**ROWAN COLLEGE AT GLOUCESTER COUNTY  
ECONOMIC DEVELOPMENT CENTER AND ROWAN MEDICINE  
Addendum #2 May 13, 2019  
COVER SHEET**

**Bid Package Clarification and Changes**

This Addendum dated May 13, 2019 for the **Economic Development Center and Rowan Medicine** shall be included as part of the Contract Bid Documents. This Addendum shall supplement and clarify the current Contract Bid Documents.

**SECTION 05510 - METAL LADDERS – ADDED PER ADDENDUM #2**

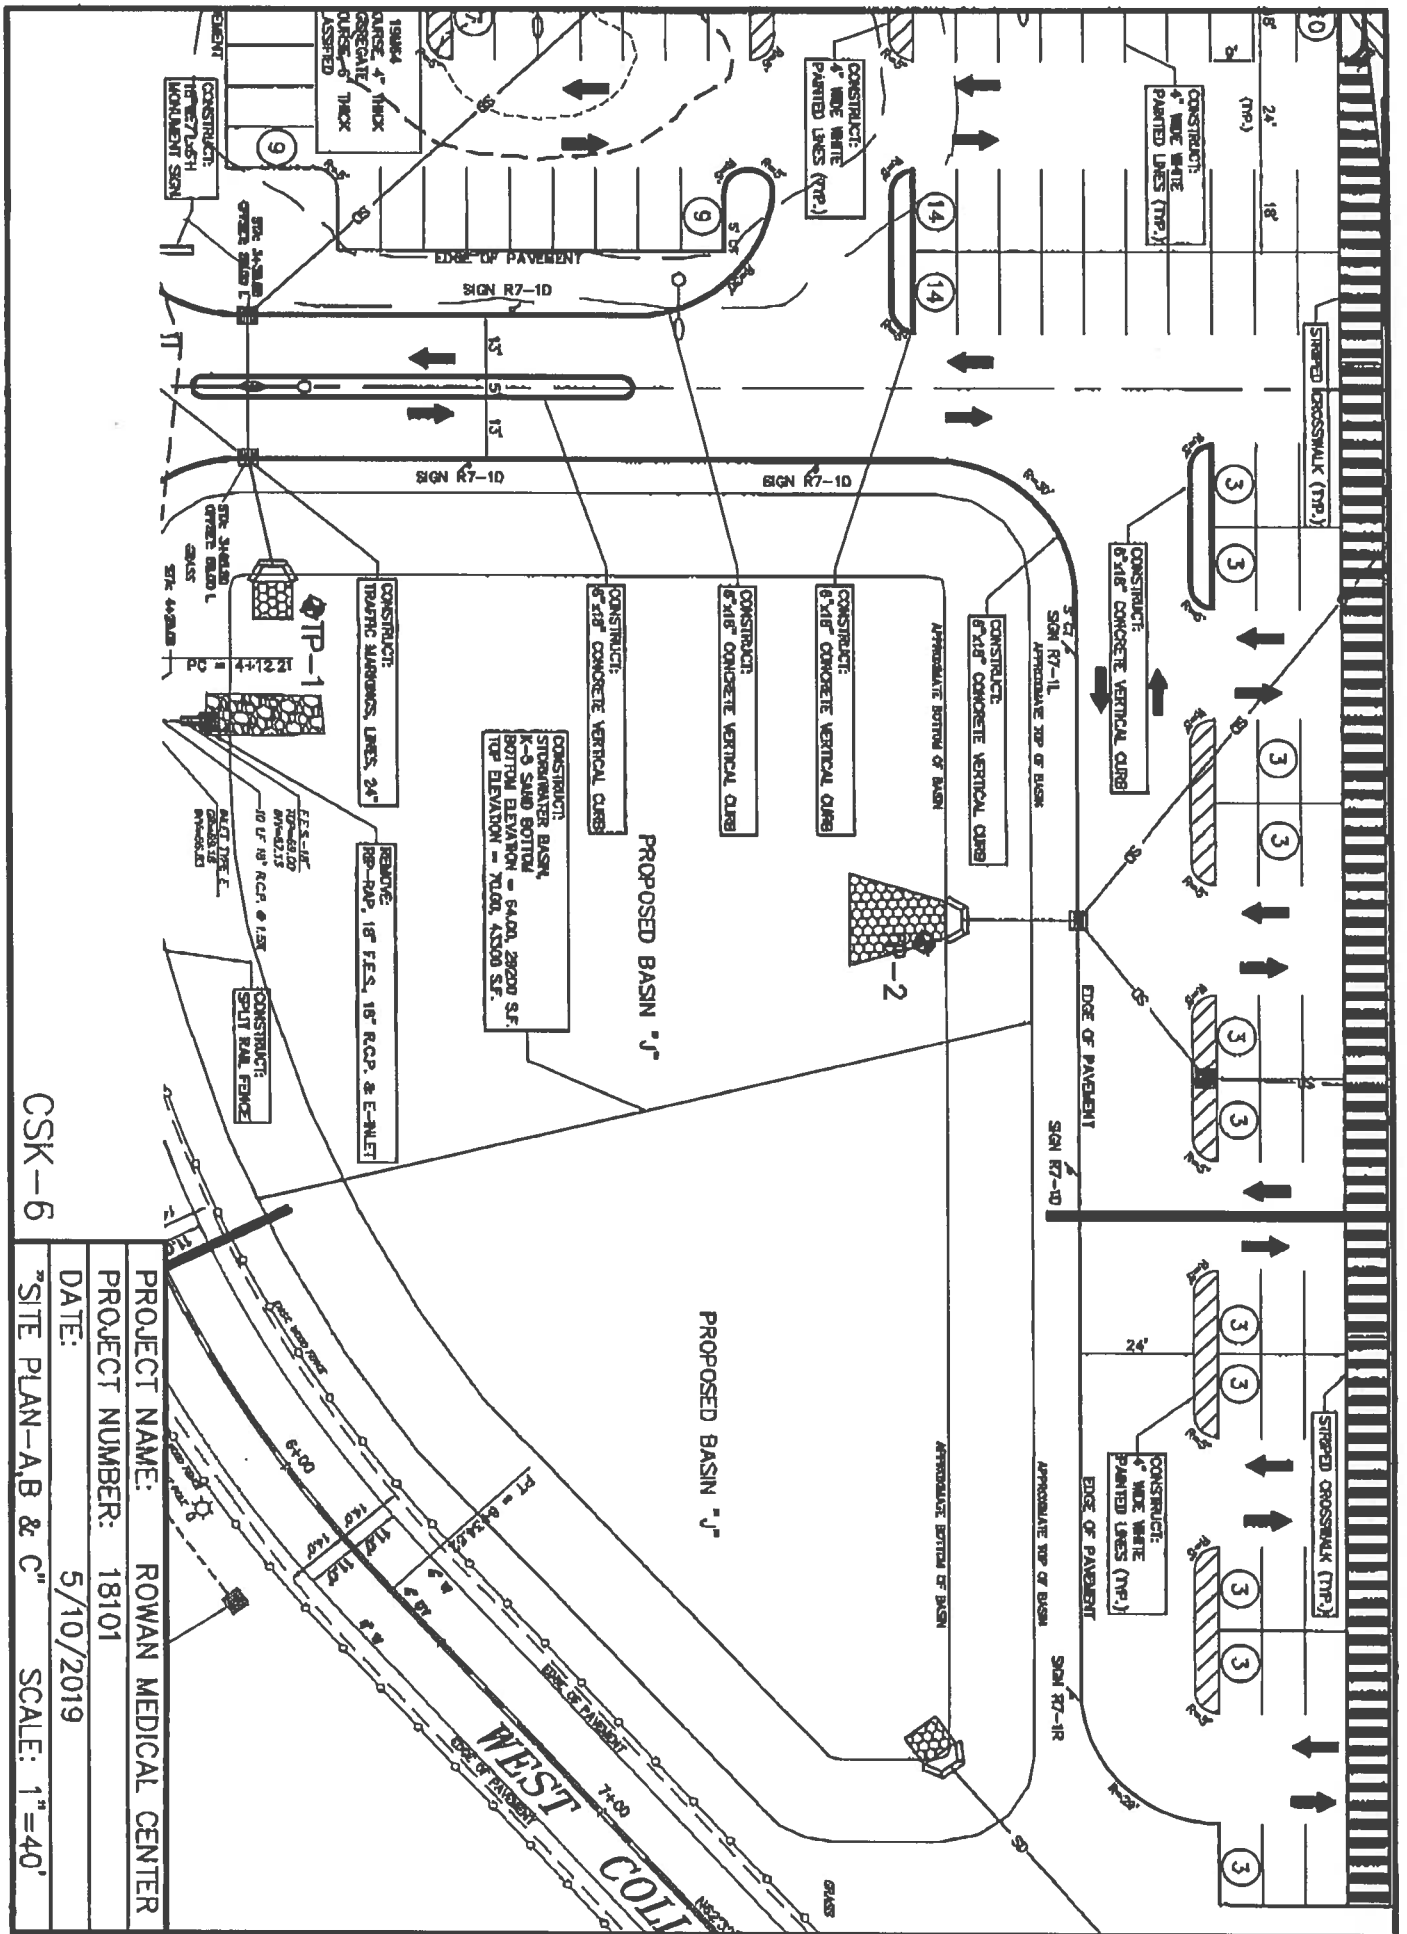
1. Space siderails 18 inches.
2. Siderails: Continuous, 3/8-by-2-1/2-inch steel flat bars, with eased edges.
3. Rungs: 1-inch- square steel bars.
4. Fit rungs in centerline of siderails; plug-weld and grind smooth on outer rail faces.

5. Provide nonslip surfaces on top of each rung, either by coating rung with aluminum-oxide granules set in epoxy-resin adhesive or by using a type of manufactured rung filled with aluminum-oxide grout.

6. Provide nonslip surfaces on top of each rung by coating with abrasive material metallically bonded to rung.
7. Provide platforms as indicated fabricated from welded or pressure-locked steel bar grating, supported by steel angles. Limit openings in gratings to no more than 3/4 inch in least dimension.

8. Support each ladder at top and bottom and not more than 60 inches o.c. with welded or bolted steel brackets. Provide a minimum 7" clear from the face of rung to the nearest obstruction for clear toe room.

9. The finish for all ladders shall be hot-dipped Galvanized steel painted in accordance with Specification Section 09900 Painting.
10. In Stairs A & B, provide the roof ladders with hinged security doors and a hasp lock to prevent pedestrians from using the ladders.

CSK-6

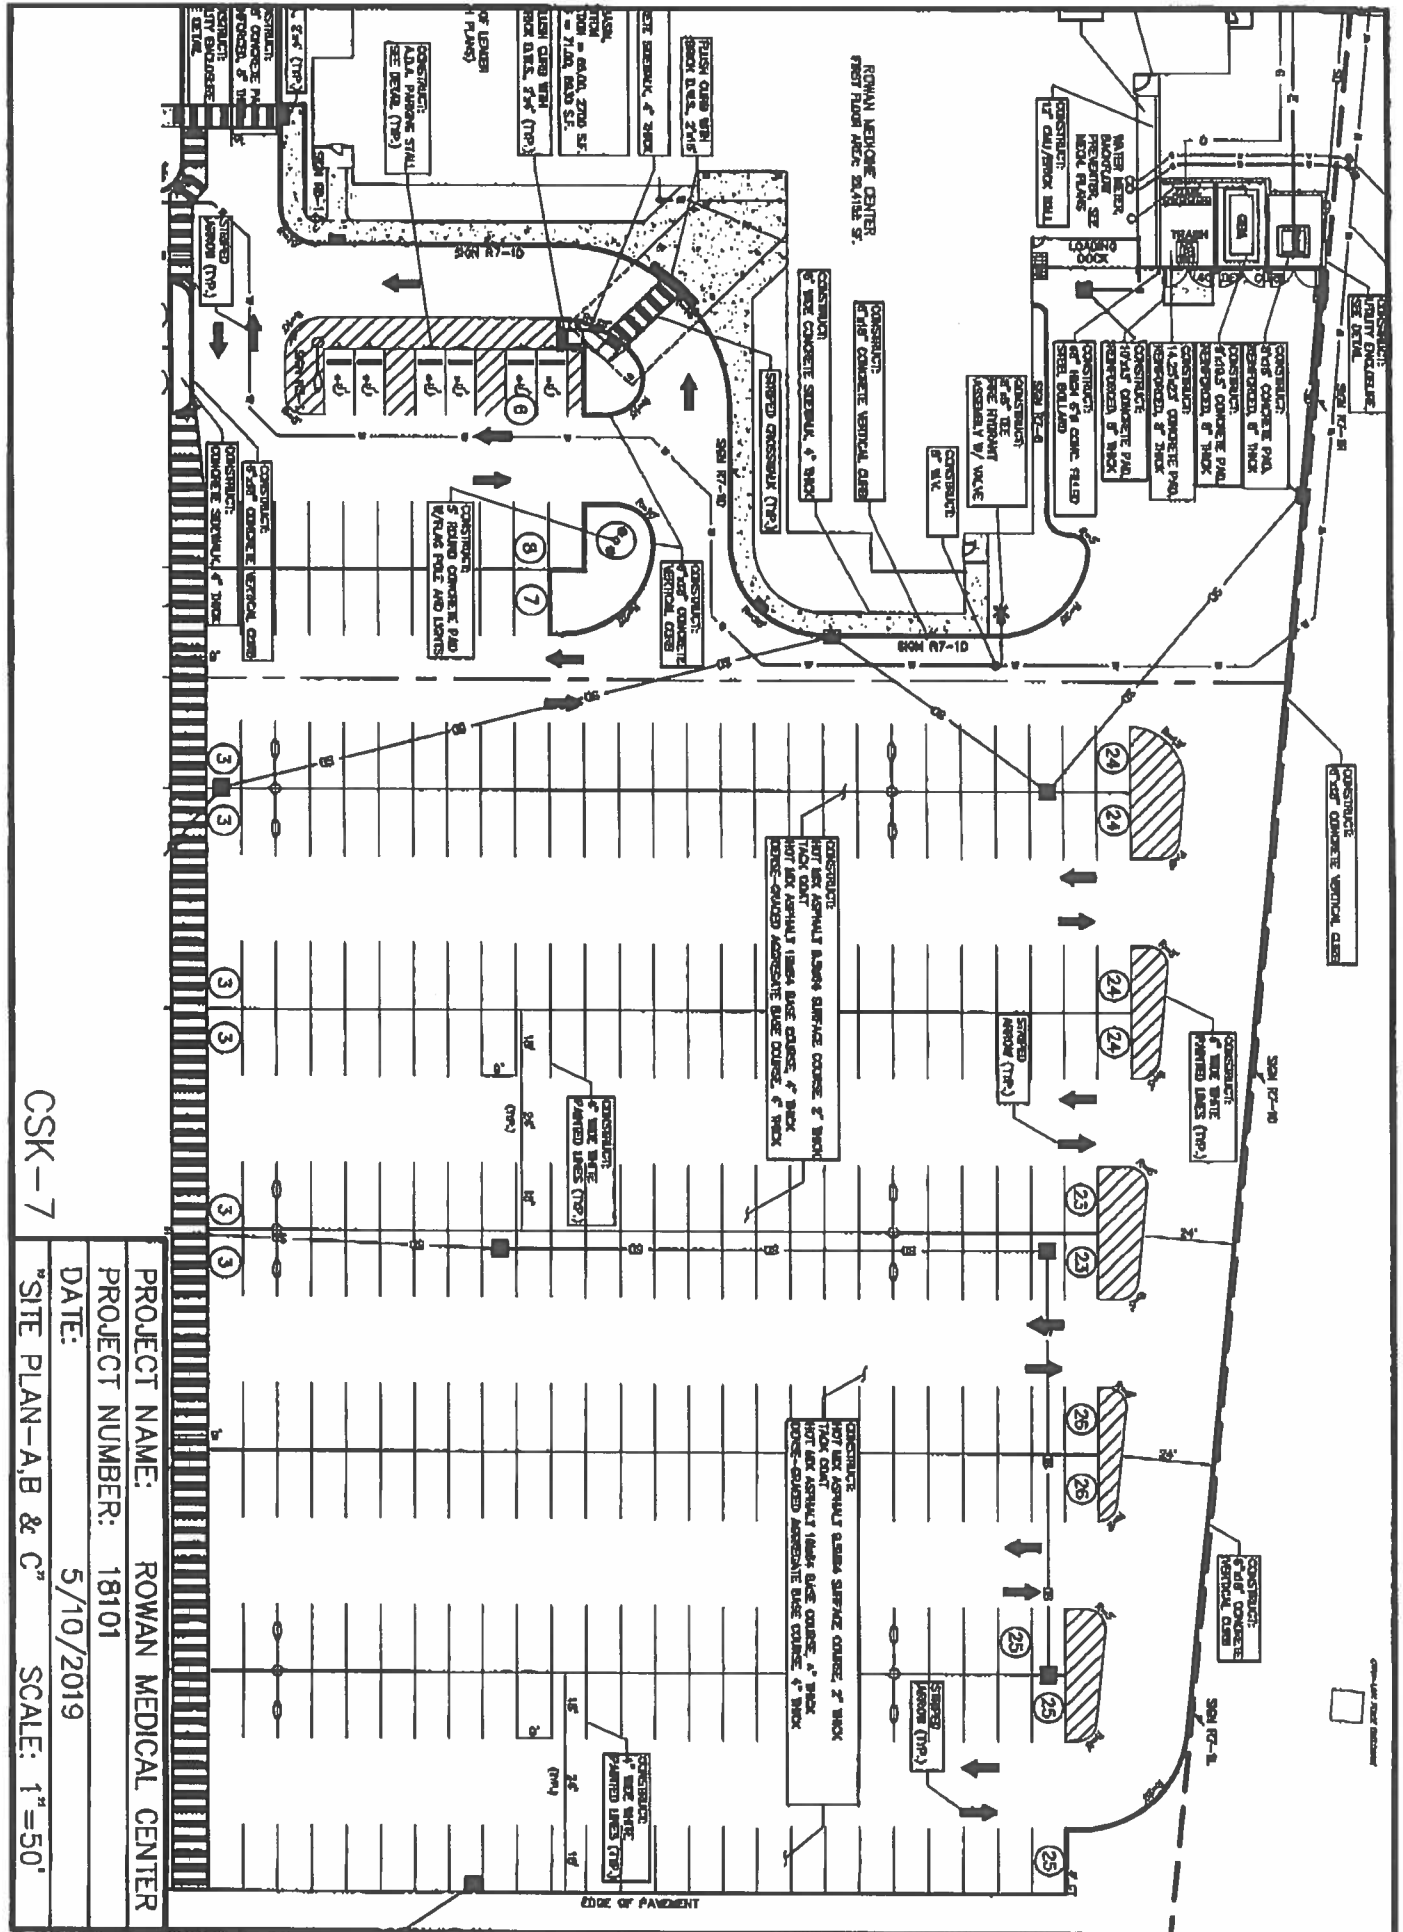
The attached sketches CSK-6 and CSK-7 dated 5/10/19 locate additional "No Parking" signage. (2 sketches)

No Parking Signs – Twenty (20) "No Parking" Signs, designated as R8-31 (18" x 24") in the Manual on Uniform Traffic Control Devices (MUTCD) shall be provided and installed as detailed on Site Plan Sheet 18, prepared by Federici & Akin, as included in the Bid Set. Locations shall be designated at the time of installation.
